ADDENDUM NO. 2

MCALLISTER PARK RECONNECTION
TO SALADO CENTRAL GREENWAY

PROJECT ID NO.: 26-00526

Briones Consulting & Engineering, Ltd.
8118 Broadway
San Antonio, TX 78209

DATE: 08/14/12
SHEET NO.
C-10

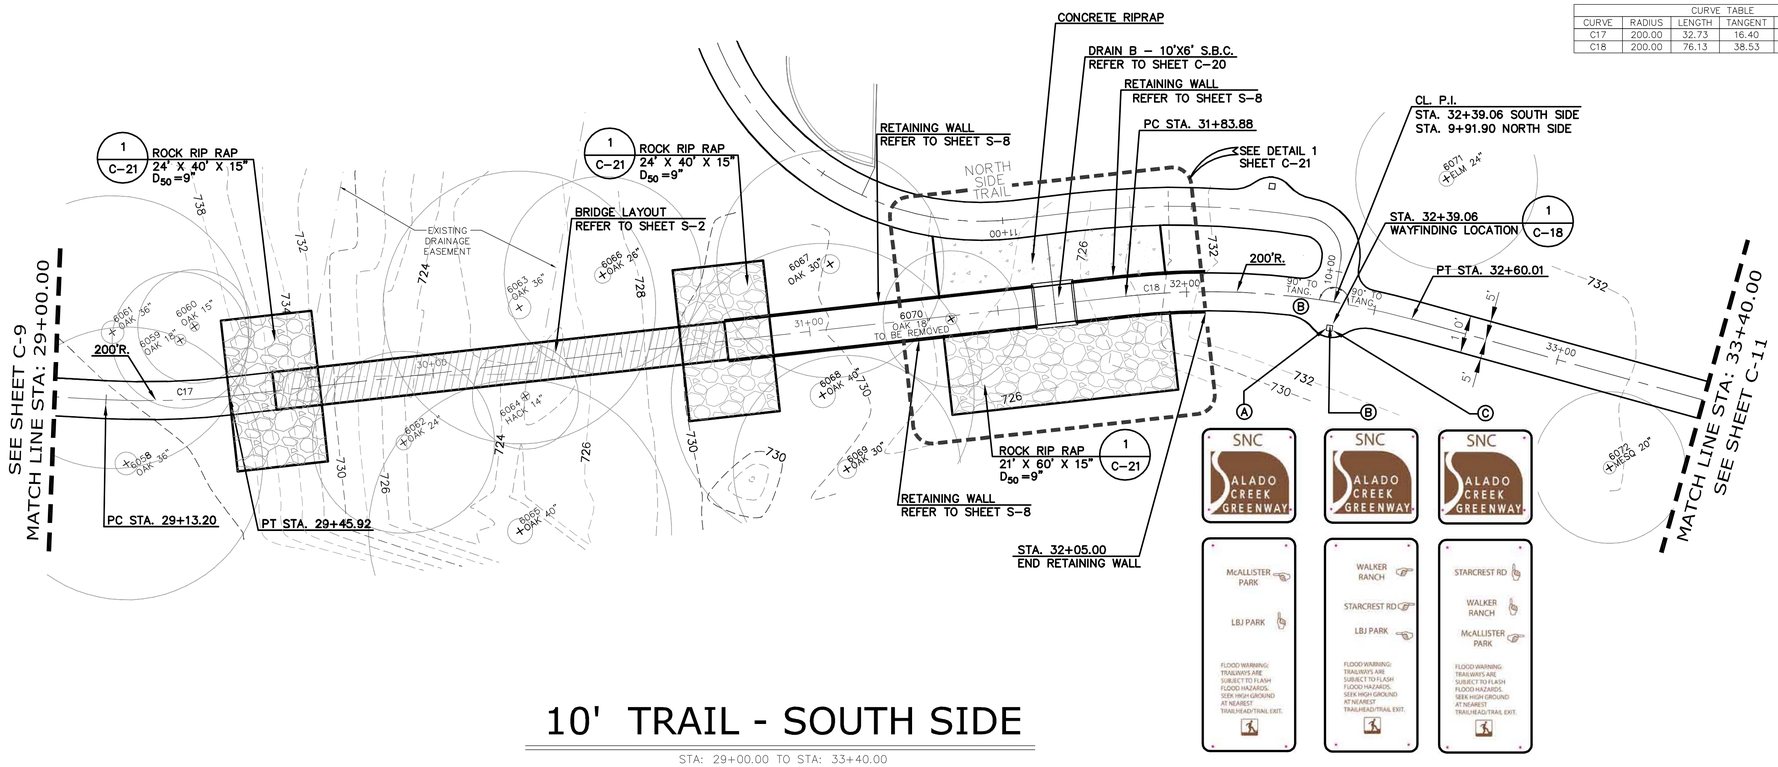
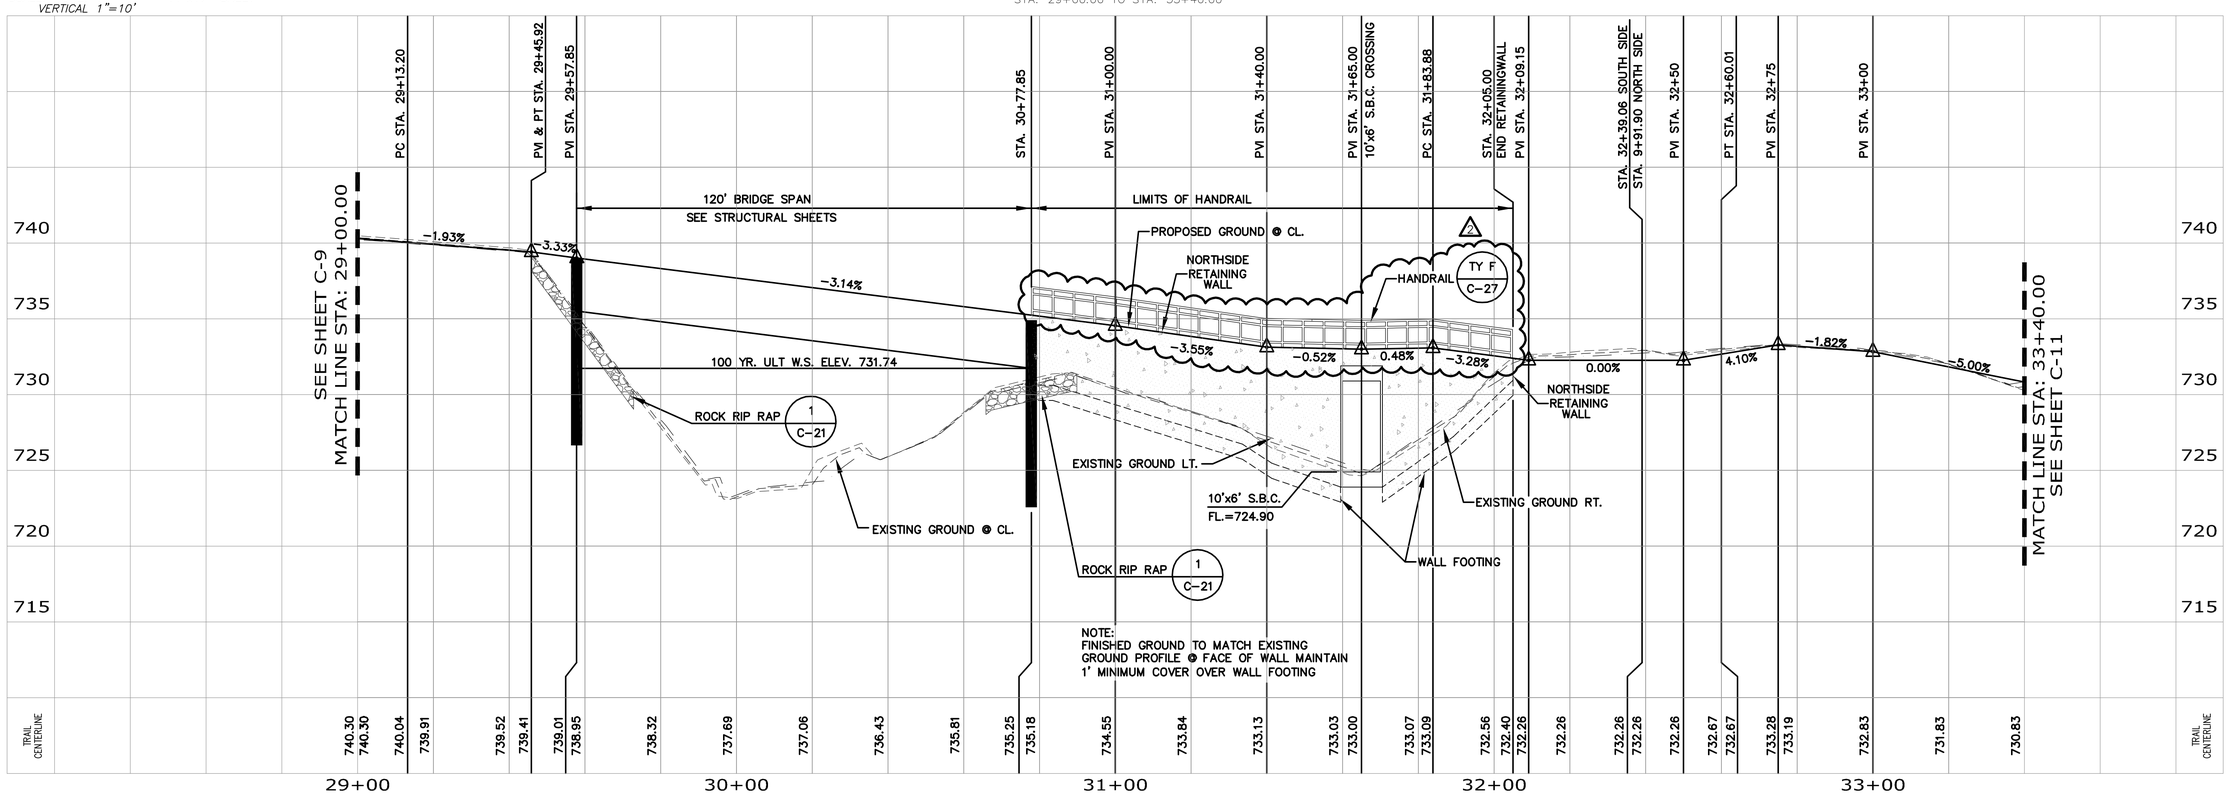
C-10 Revised handrail detail callout in profile referencing Type F rail on Sheet C-27

DATE: 08/14/12
SHEET NO.
C-11

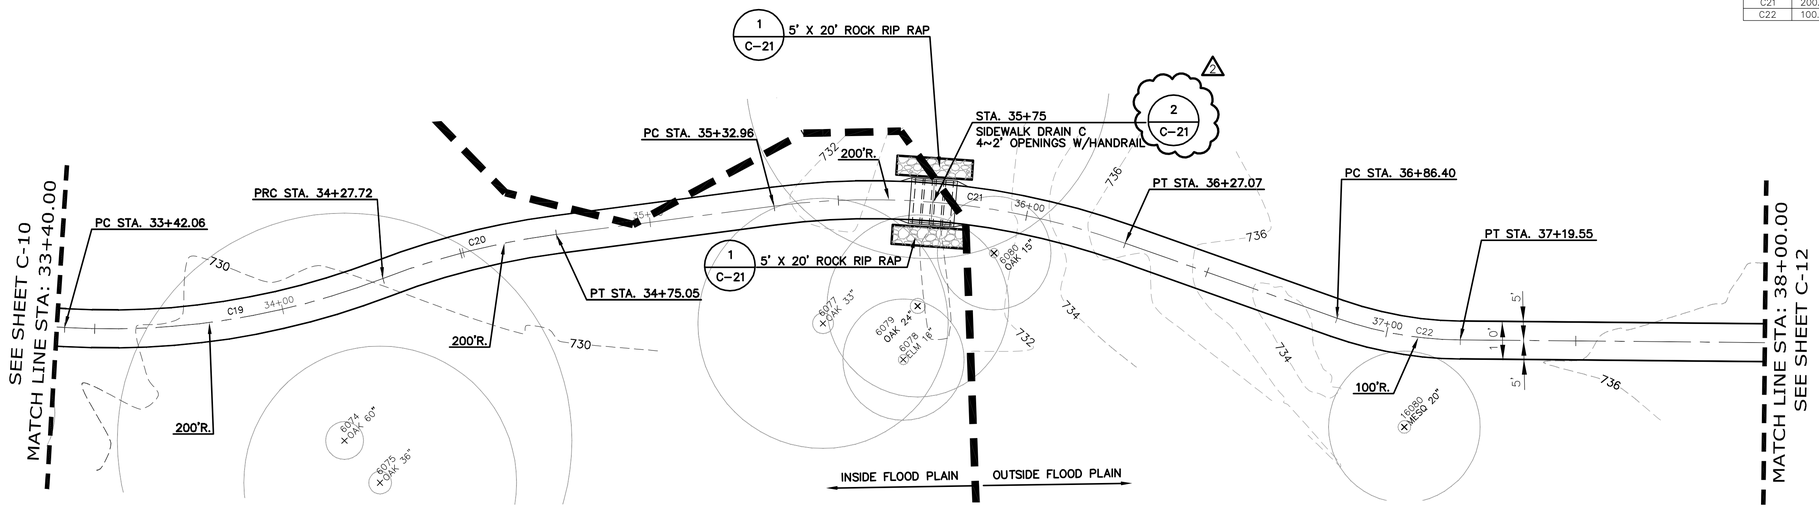
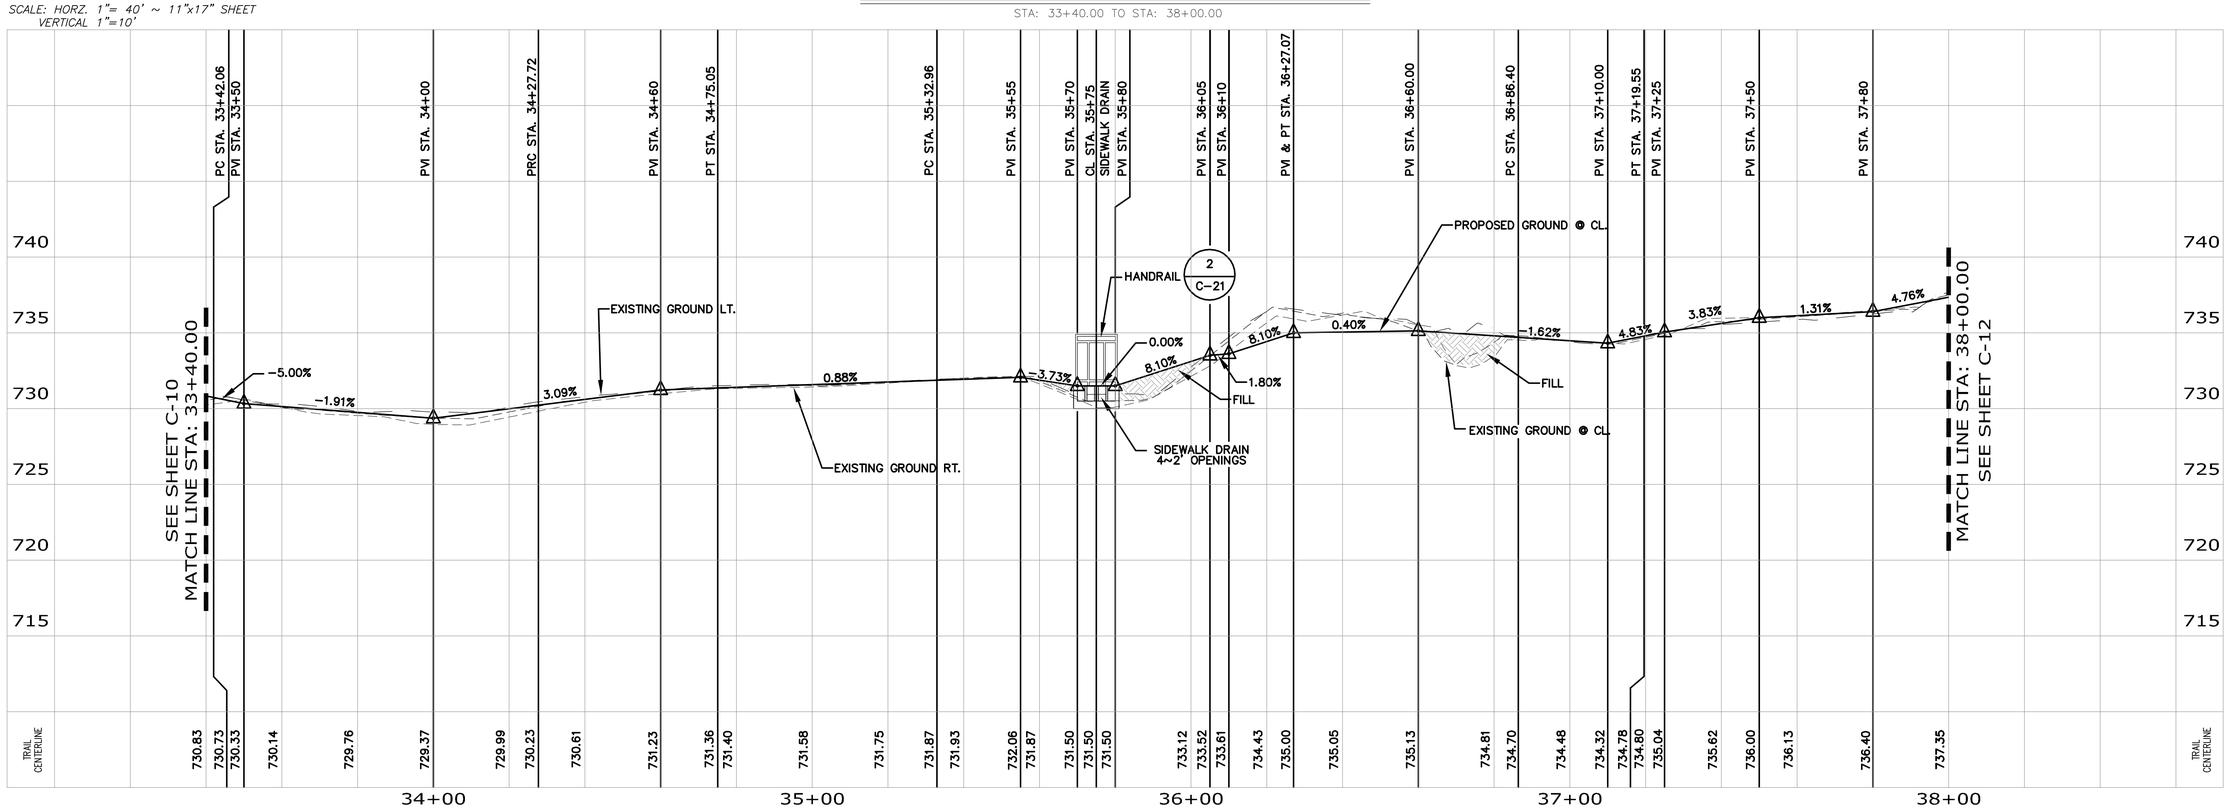
C-11 Corrected Handrail detail callout in plan view.

DATE: 09/11/12
SHEET NO.
C-27

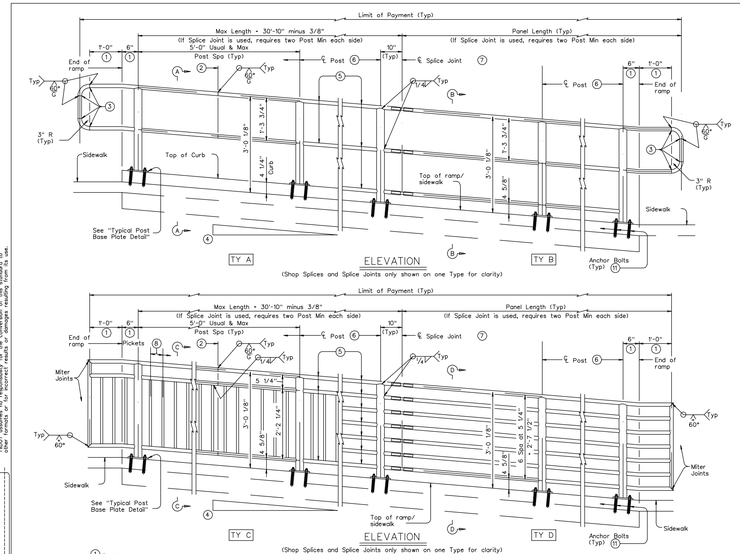
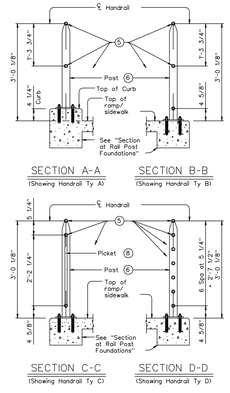
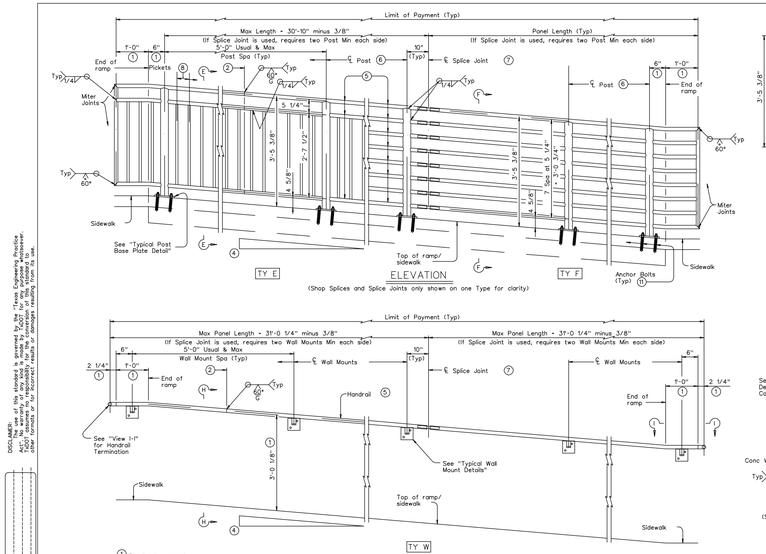
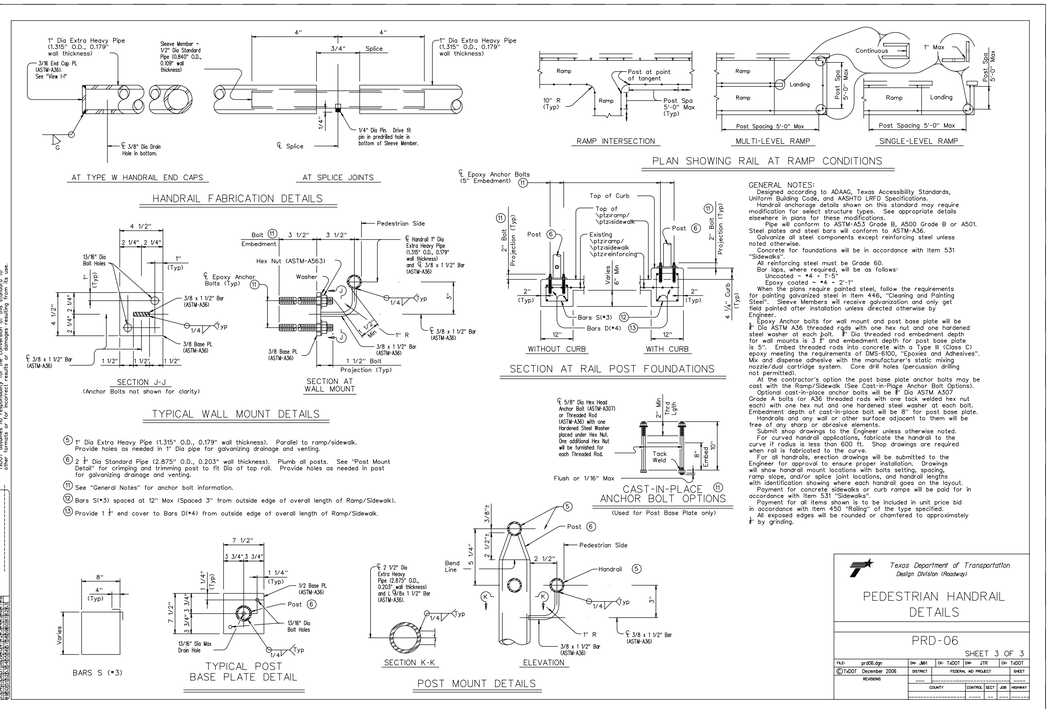
C-27 Added a Pedestrian Handrail Detail sheet. Use Type F where noted on plans.
